Independent Qualified Registered Professional Engineer Design Assessment Report For Integrated Disposal Facility (IDF) Leachate Transfer Pipeline

**IQRPE Design Assessment Report
No. DA-332610-01
Rev. 0**

Meier Project No. 20-8692
DGR Grant Construction Contract No. 332610
CHPRC Contract No. 72435

December 9, 2020

Figure 4: Leachate Transfer Line and Sump Locations (Drawing: ECR-18-001801, Page 10)

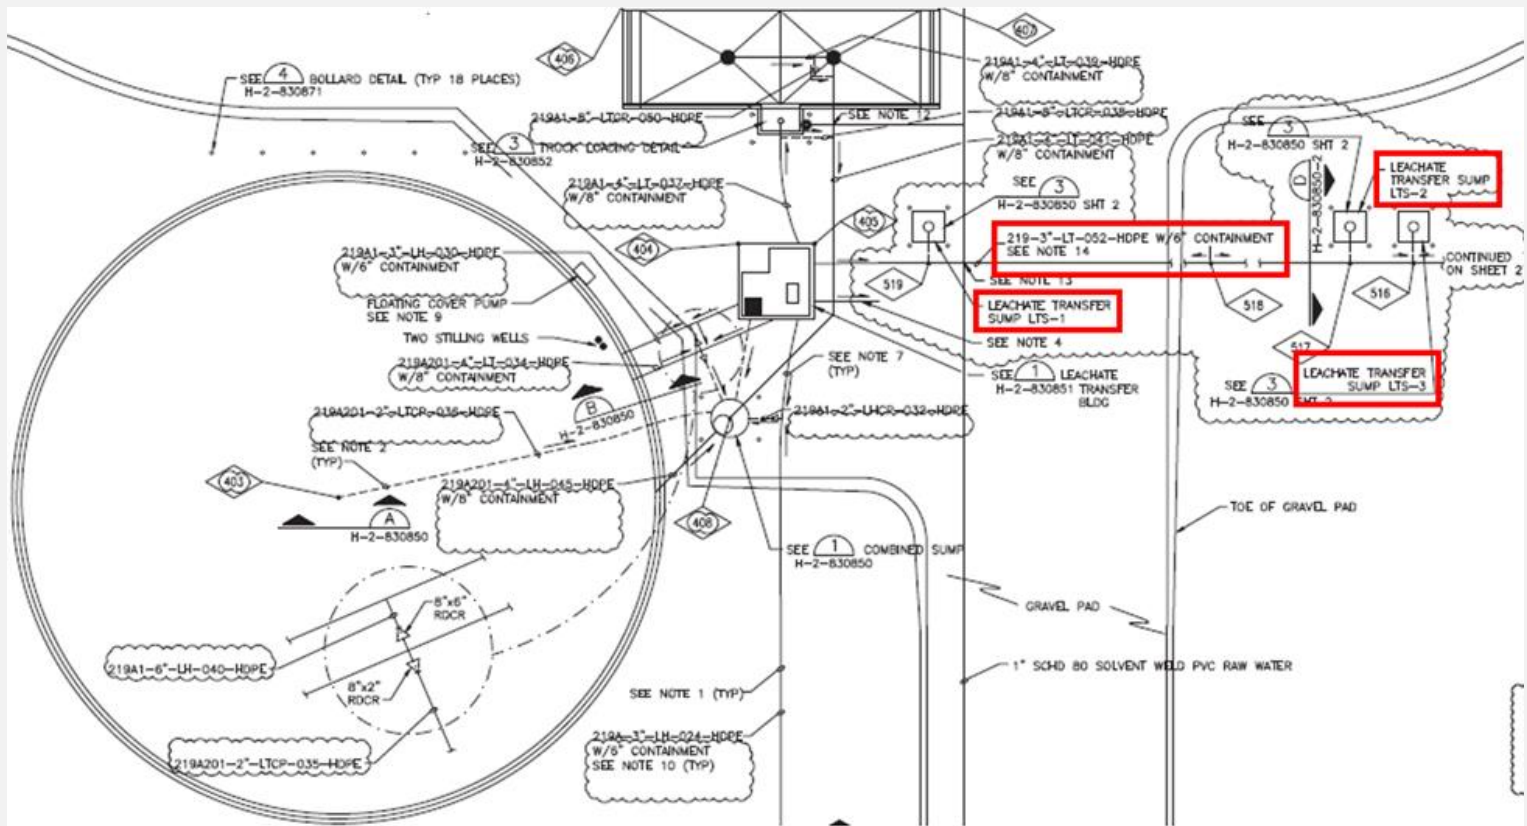
The pipeline is sloped at 0.5%, which prevents it from trapping liquid, and has a minimum of 3’ 6” of soil cover over its top which serves to protect it from freezing temperatures (ECR-18-001801, Page 12 and CHPRC-03953, Section 33 05 33.23 – 3.3 S).

Figure 7: P&ID (Drawing: ECR-18-001801, Page 18)

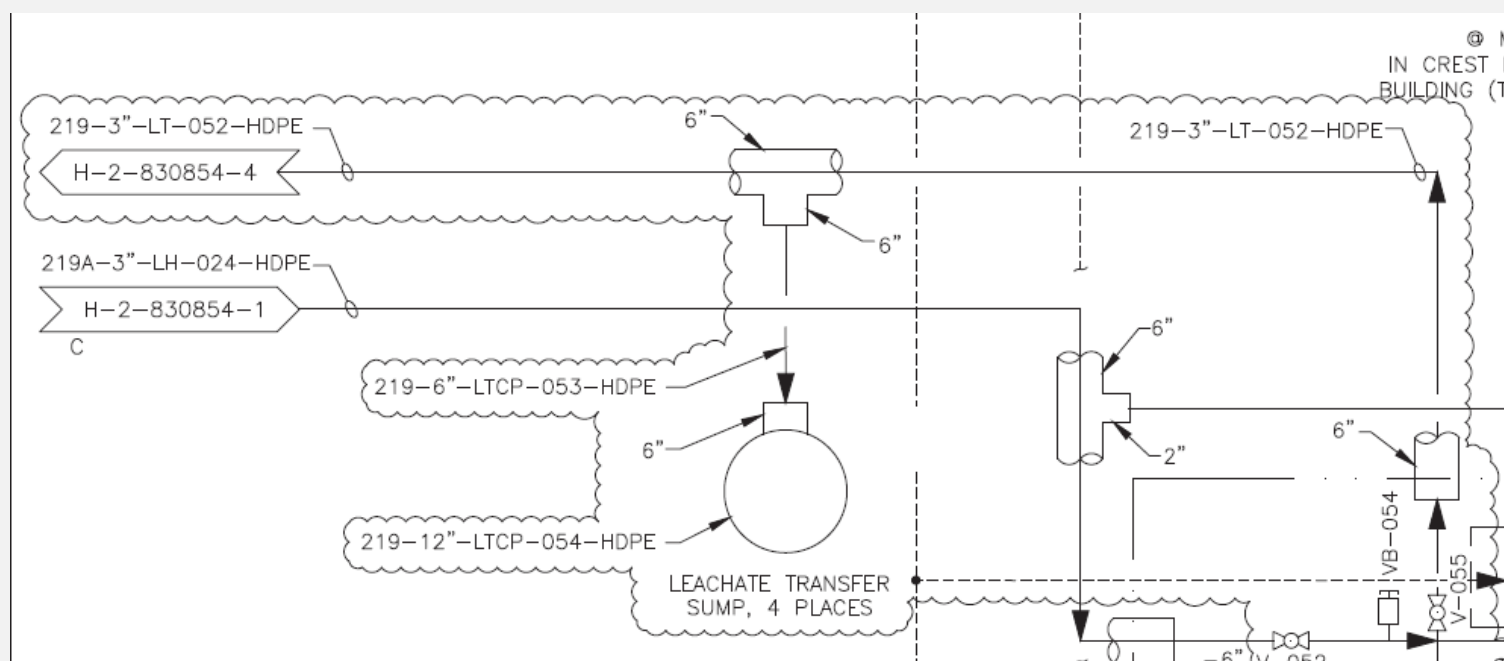
The P&ID details for the IDF Leachate Transfer Pipeline are depicted on drawings H-2-830854, Sheets 1-2, *IDF Cell #1 P&ID* and H-2-830854, Sheets 3-4, *IDF Cell #2 P&ID*; and as modified by ECR-18-001801.

The IQRPE concludes that the appropriate P&ID review has been made.
